# UNITED STATES PATENT AND TRADEMARK OFFICE

APPLICATION NO.	FILING DATE	FIRST NAMED INVENTOR	ATTORNEY DOCKET NO.	CONFIRMATION NO.
10/664,703	09/18/2003	Eric Holmes	71034	5196
23872	7590	04/22/2005	EXAMINER	
MCGLEW & TUTTLE, PC P.O. BOX 9227 SCARBOROUGH STATION SCARBOROUGH, NY 10510-9227			FERGUSON, MICHAEL P	
		ART UNIT		PAPER NUMBER
				3679

<b>Office Action Summary</b>	<b>Application No.</b>	<b>Applicant(s)</b>	
	10/664,703	HOLMES, ERIC	
	<b>Examiner</b>	<b>Art Unit</b>	
	Michael P. Ferguson	3679

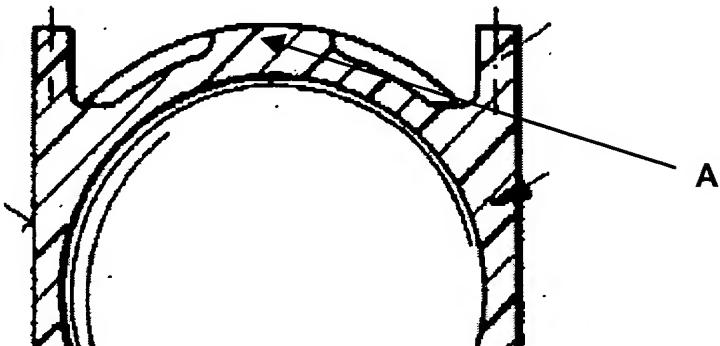
As to claim 4, Schutt et al. disclose a ball-and-socket joint wherein the bearing shell surface **3b** includes extension segments **3d,A** (Figure 2 reprinted below with annotations) integral with the bearing shell surface and extending from a region of the bearing shell surface disposed on the housing part **1**, the extension segments being formed to a shape to form a joint ball end region bearing surface (Figure 1).
